NORTHERN WOLVES
AIR CONDITIONING

Ref. Quote: 3112 / Date: 10/6/2026 / Rev 1

Project: **Sunrise Rye Brook - 900 King St, Rye Brook, NY 10573**

Value Engineering Mark-ups - VAV zoning, cabinet heaters, basement fan coils

**INDEPENDENT LIVING
FIRST FLOOR PLAN -
MECHANICAL IL AREA**

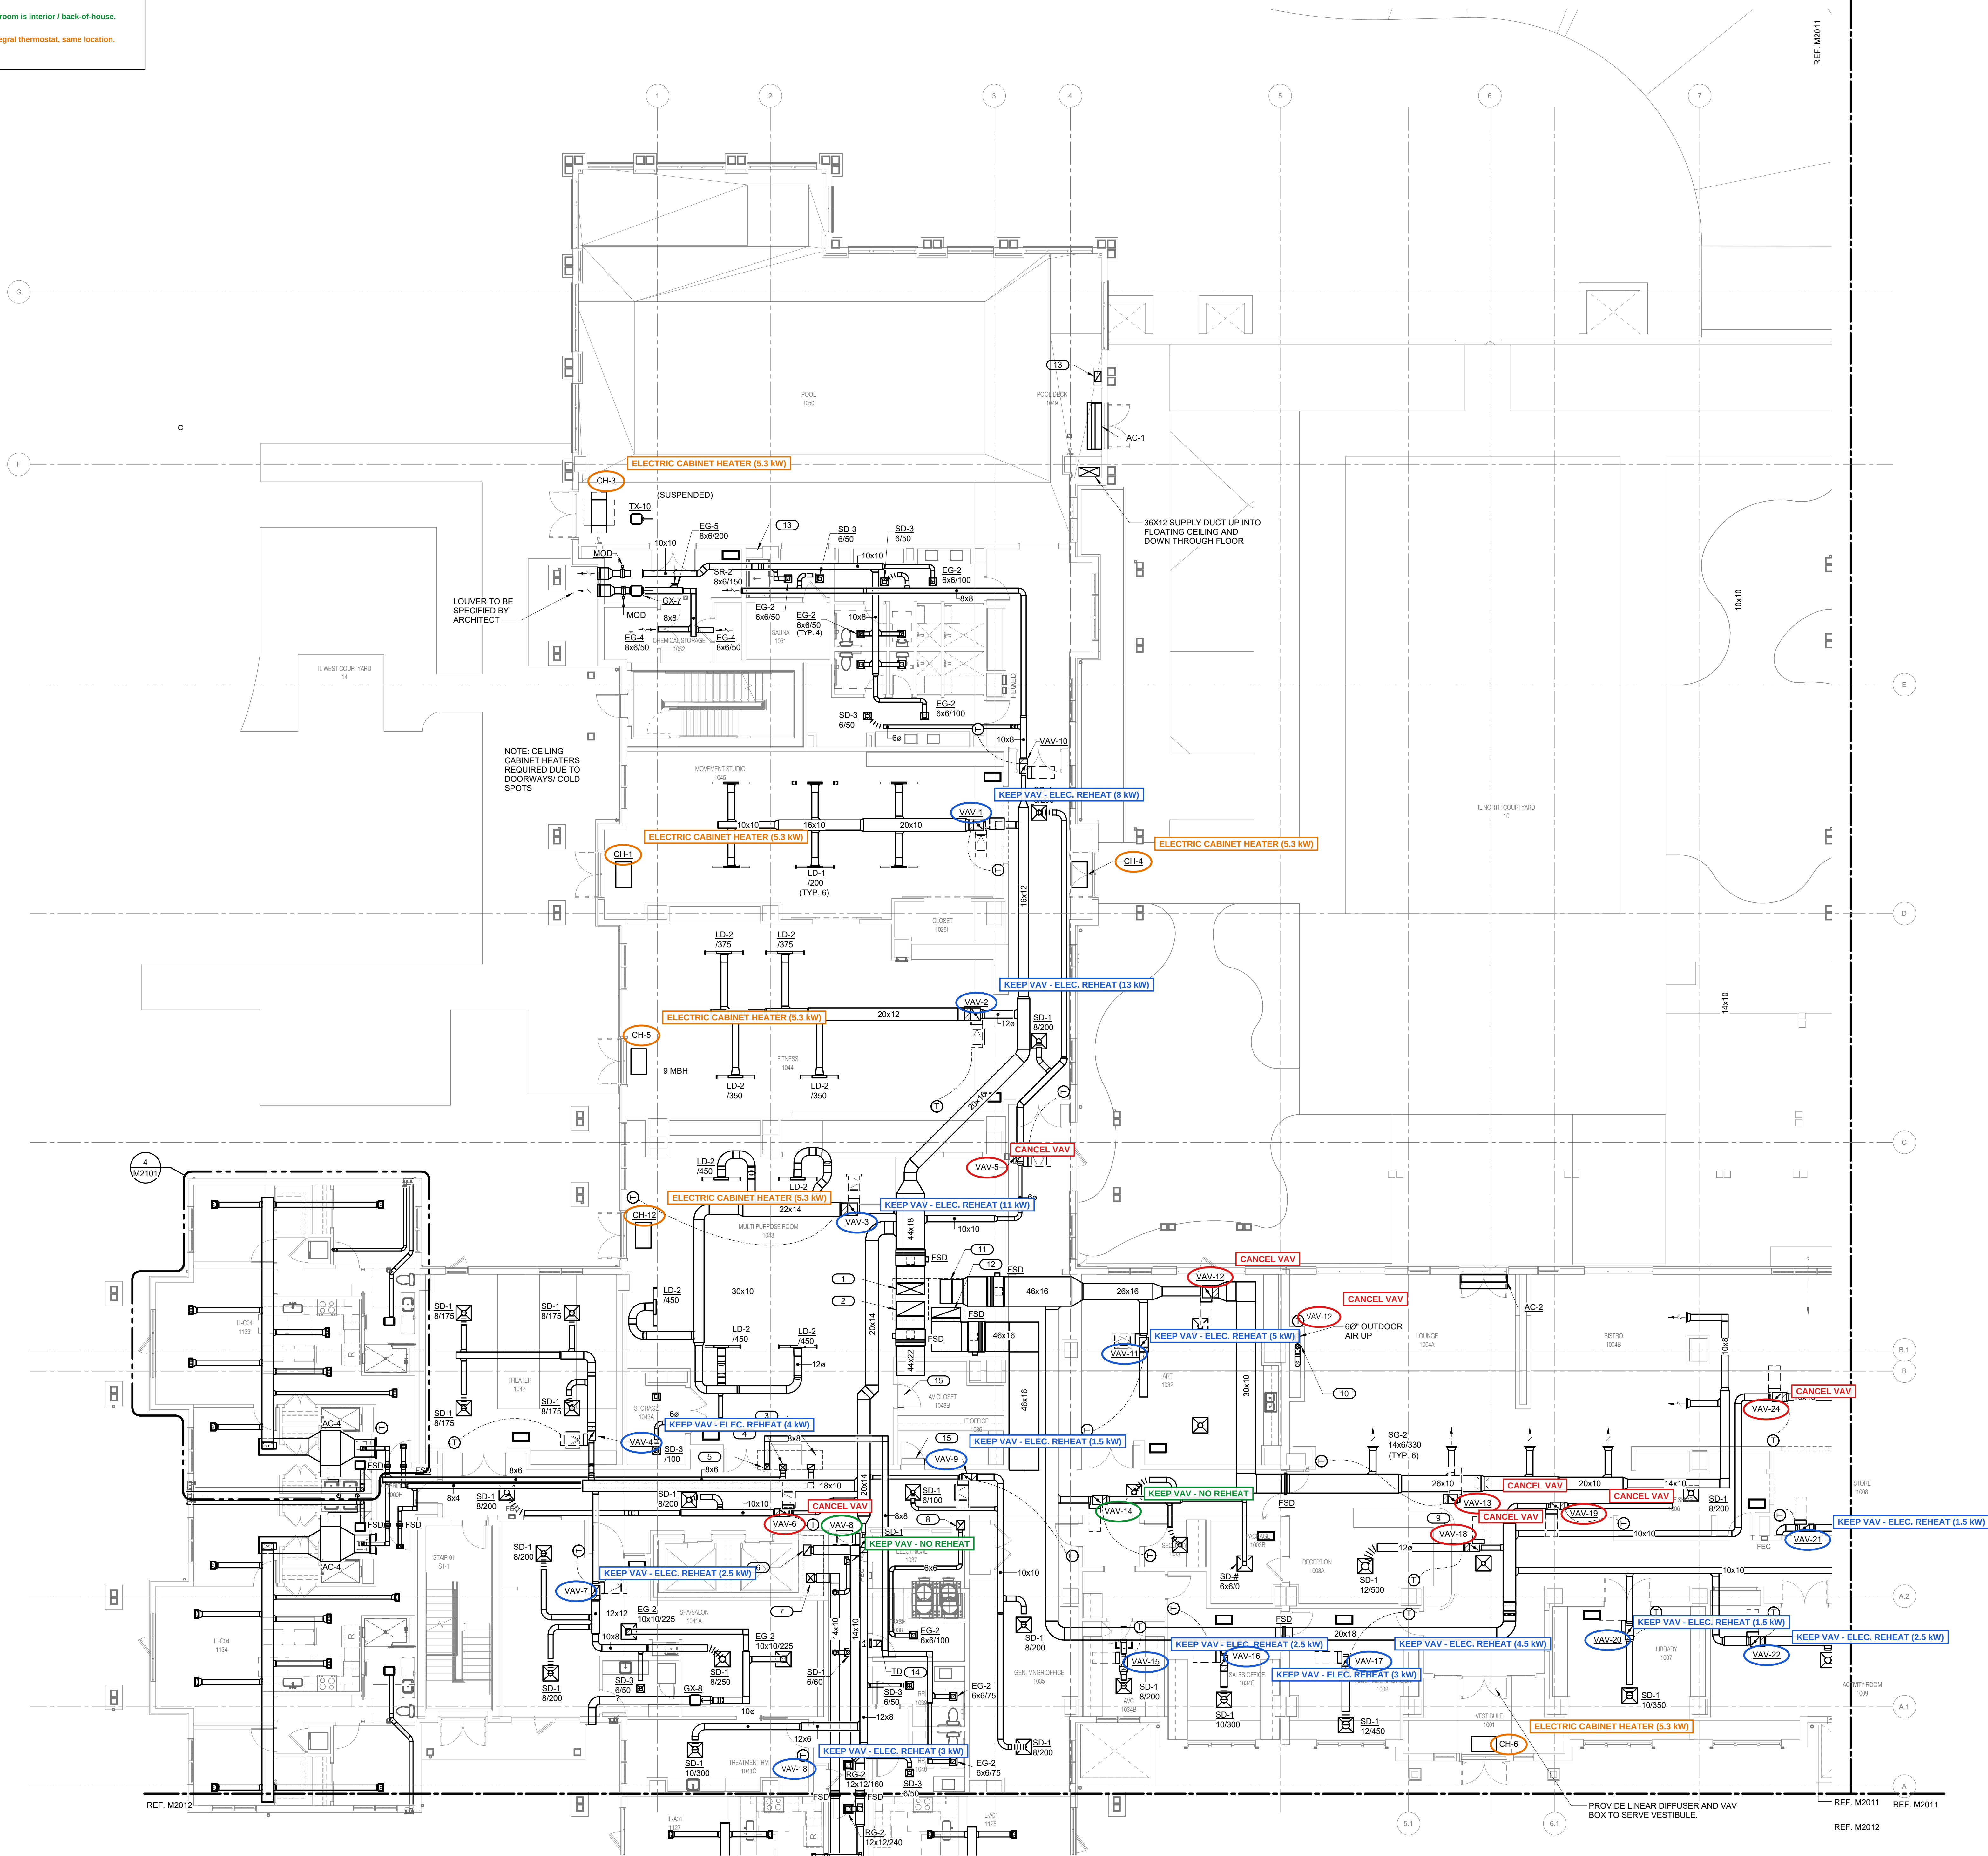
The following sheets of the GMP mechanical set are marked up with our proposals. Same rooftop units as designed (gas heat). VAV boxes in open areas and circulation are cancelled and the areas are served directly from the rooftop units; VAV boxes stay in enclosed rooms, with electric reheat and simple standalone thermostats where reheat is needed, and with no reheat in interior / back-of-house rooms. Hot water cabinet heaters and basement fan coils are replaced by electric heaters. Rooms that need cooling or ventilation are listed in RFI-01 (last page) and are not priced. Pool, spa and sauna are by others.

Mark	Meaning
CANCEL VAV	Cancel VAV box (open area / circulation). Branch duct stays with manual volume damper, balanced to design max CFM; area served directly by the RTU (RTU space sensor here). Gas heat from the RTU.
KEEP VAV - ELEC. REHEAT	Keep VAV box. Electric reheat coil with SCR in lieu of hot water coil; simple standalone thermostat. No hot water piping or control valve.
KEEP VAV - NO REHEAT	Keep VAV box, cooling only. No reheat required: RTU is gas heat and the room is interior / back-of-house. Standalone thermostat.
ELECTRIC CABINET HEATER	Replace hot water cabinet heater with electric cabinet heater with integral thermostat, same location. Delete hot water piping. Power by EC.
DELETE FCU - ELEC. UNIT HEATER	Delete hot water / glycol FCU. Electric unit heater with integral thermostat. DOAS branch duct extended directly to the room diffuser; return grille deleted.
DELETE FCU - SEE RFI-01	Delete heating-only FCU. Room needs cooling / ventilation, not heat: see RFI-01 (not priced).

Cancel 18 / keep with electric reheat 25 / keep without reheat 4 / no change 1 (one tag, VAV-18, appears twice on M2010). Electric reheat kW = scheduled hot water reheat MBH / 3.412, rounded up to 0.5 kW (approx., final sizing by IMEG): total about 97 kW connected, versus about 185 kW if all 47 boxes were electric.

Sheet	VAV	Room / area served	Note	Proposal	Elec. heat
M2010	VAV-1	Movement Studio 1045		KEEP VAV - ELEC. REHEAT	8 kW
M2010	VAV-2	Fitness 1044		KEEP VAV - ELEC. REHEAT	13 kW
M2010	VAV-3	Multi-Purpose Room 1043		KEEP VAV - ELEC. REHEAT	11 kW
M2010	VAV-4	Theater 1042		KEEP VAV - ELEC. REHEAT	4 kW
M2010	VAV-5	Corridor / gallery		CANCEL VAV	-
M2010	VAV-6	Corridor		CANCEL VAV	-
M2010	VAV-7	Spa / Salon 1041A		KEEP VAV - ELEC. REHEAT	2.5 kW
M2010	VAV-8	IT Office 1036 / AV Closet		KEEP VAV - NO REHEAT	-
M2010	VAV-9	Gen. Manager Office 1035		KEEP VAV - ELEC. REHEAT	1.5 kW
M2010	VAV-10	Locker rooms / sauna (pool area)	Pool / sauna by others - not marked	NO CHANGE	-
M2010	VAV-11	Art 1032		KEEP VAV - ELEC. REHEAT	5 kW
M2010	VAV-12	Lounge 1004A		CANCEL VAV	-
M2010	VAV-13	Lounge / Bistro 1004A-B		CANCEL VAV	-
M2010	VAV-14	Security 1033 / Package 1003B		KEEP VAV - NO REHEAT	-
M2010	VAV-15	AVC 1034B		KEEP VAV - ELEC. REHEAT	2.5 kW

M2010	VAV-16	Sales Office 1034C		KEEP VAV - ELEC. REHEAT	3 kW
M2010	VAV-17	Family Meeting Room 1002		KEEP VAV - ELEC. REHEAT	4.5 kW
M2010	VAV-18	Reception 1003A		CANCEL VAV	-
M2010	VAV-18	Treatment Rm 1041C	Tag duplicated on drawing - clarify	KEEP VAV - ELEC. REHEAT	3 kW
M2010	VAV-19	Coffee Shop 1006		CANCEL VAV	-

All hot water cabinet heaters on the plans become electric with integral thermostats. CH-8 is in the schedule but not shown on the plans; CH-2 is not used. Please confirm.

Sheet	Tag	Location	Proposal	Elec. heat
M2010	CH-1	Movement Studio entry	ELECTRIC CABINET HEATER	5.3 kW
M2010	CH-3	Pool deck / stair entry	ELECTRIC CABINET HEATER	5.3 kW
M2010	CH-4	Exterior door at gallery	ELECTRIC CABINET HEATER	5.3 kW
M2010	CH-5	Fitness entry	ELECTRIC CABINET HEATER	5.3 kW
M2010	CH-12	Multi-Purpose Room entry	ELECTRIC CABINET HEATER	5.3 kW
M2010	CH-6	Vestibule 1001	ELECTRIC CABINET HEATER	5.3 kW
M2011	CH-7	Formal Dining entry	ELECTRIC CABINET HEATER	5.3 kW
M2011	CH-9	Trash 1030 / Storage	ELECTRIC CABINET HEATER	10.4 kW
M2011	CH-10	Casual Dining entry	ELECTRIC CABINET HEATER	5.3 kW
M2011	CH-11	Casual Dining entry	ELECTRIC CABINET HEATER	5.3 kW
		Total (scheduled MBH / 3.412)		58.1 kW

Sheet M2011 (GMP set 07.15.2026). For discussion - not a design document.

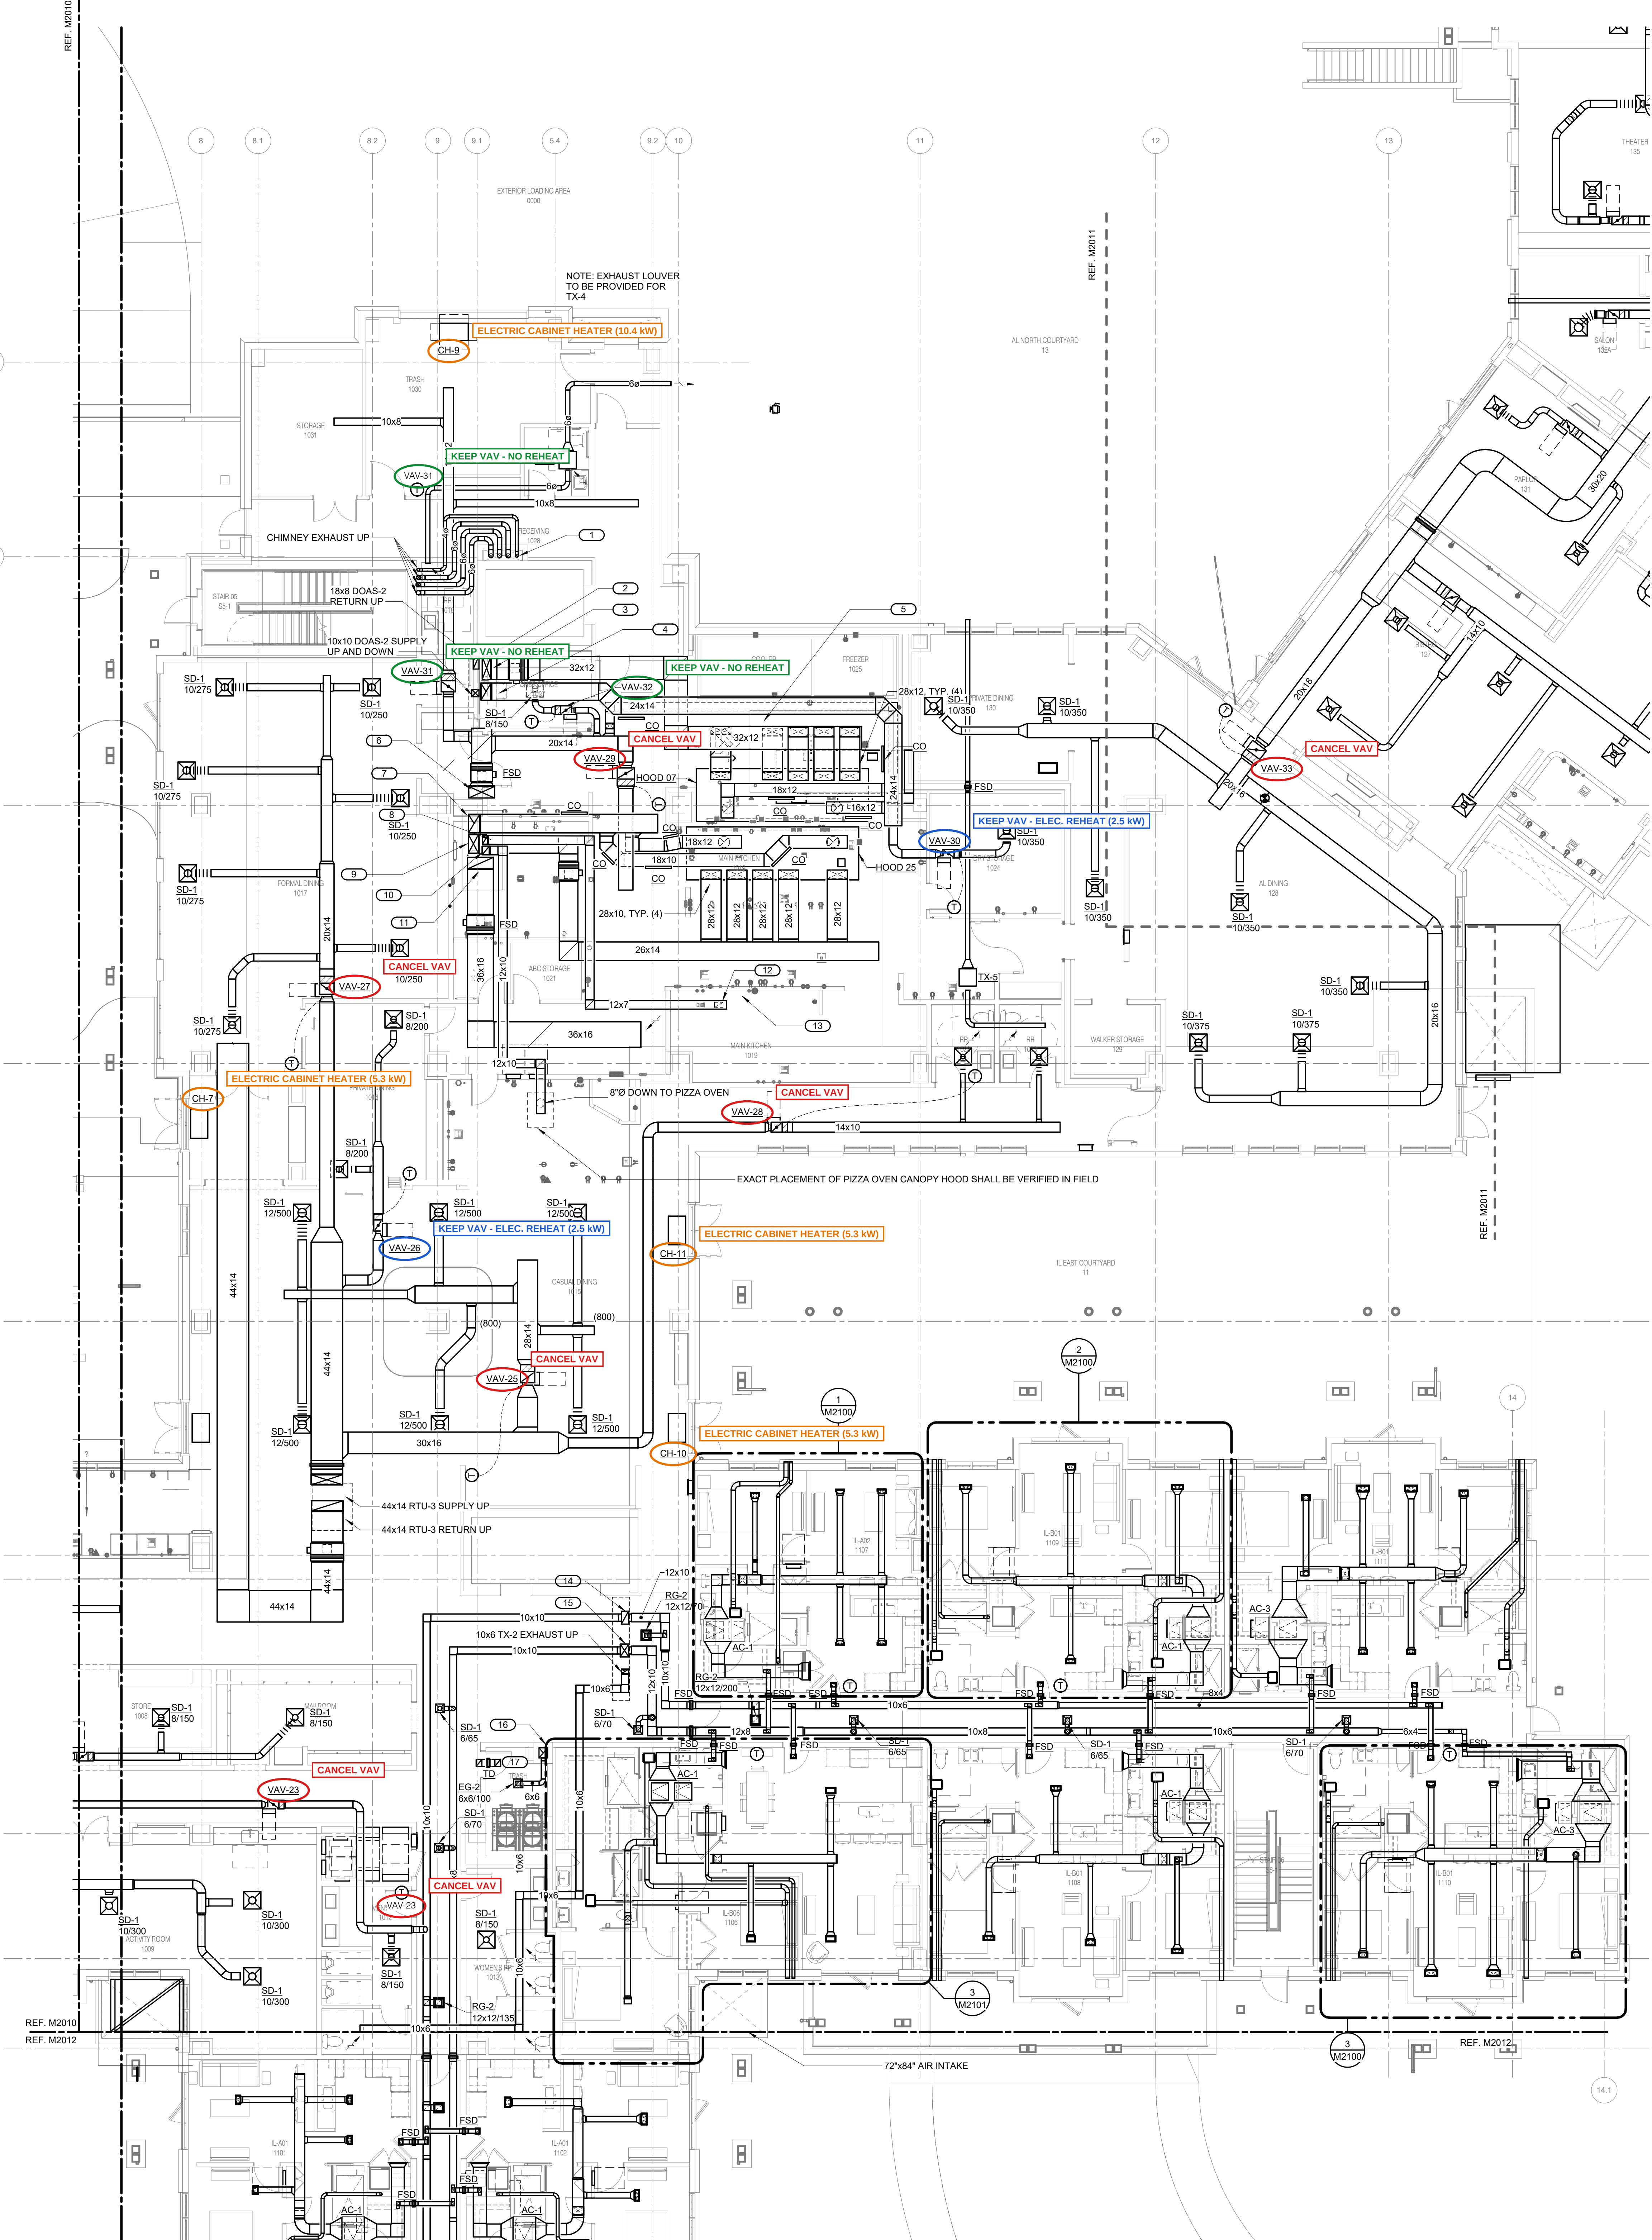
CANCEL VAV (8): Cancel VAV box (open area / circulation). Branch duct stays with manual volume damper, balanced to design max CFM; area served directly by the RTU (RTU space sensor here). Gas heat from the RTU.

KEEP VAV - ELEC. REHEAT (2): Keep VAV box. Electric reheat coil with SCR in lieu of hot water coil; simple standalone thermostat. No hot water piping or control valve.

KEEP VAV - NO REHEAT (2): Keep VAV box, cooling only. No reheat required; RTU is gas heat and the room is interior / back-of-house. Standalone thermostat.

ELECTRIC CABINET HEATER (4): Replace hot water cabinet heater with electric cabinet heater with integral thermostat, same location. Delete hot water piping. Power by EC.
